CERTIFICATE OF APPROPRIATENESS

Property: 1117 Peddie St. – 5,000 SF partially vacant lot – Lot 16, Block 108, North Norhill

Proposal: New Construction

Recommendation: Denial - does not satisfy criteria [Sec. 33-242, (1), (2), (3), and (4)]

SOUTH ELEVATION

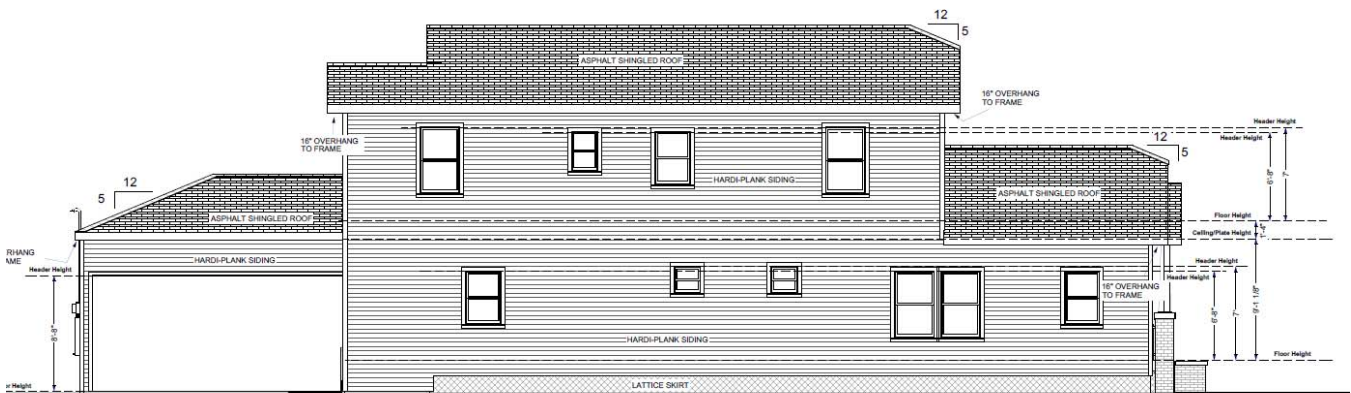
The proposed carport ridge height of 16'6 1/4" and eave height of 11' 51/8" appears significantly taller than that of similar carports and garages in the context area. (This has been discussed and the applicant has agreed to an earlier submitted version of the carport which is compatible.)

The height of the proposed 2-story structure, 27' 7 1/8", exceeds that of the typical contributing structures in the context area.

The second floor is too far forward. The second floor is only 15' - 8" behind the front wall of the house. A second floor must be subordinate to a one-story volume. For remodeling projects, a second floor should be set back at least half the distance between the front wall of the existing structure and the furthest point of the rear of the existing structure. This is a complete new house but the placement of the second floor does follow the spirit of this requirement. In an informal measurement of second floor additions in Norhill most were at least 25' back from the front face of the house.

It is most important for any second story to be as modest as possible so as not to overwhelm the existing first floor. This means a second story plate height of 8'. The proposal has a plate height of 9'.
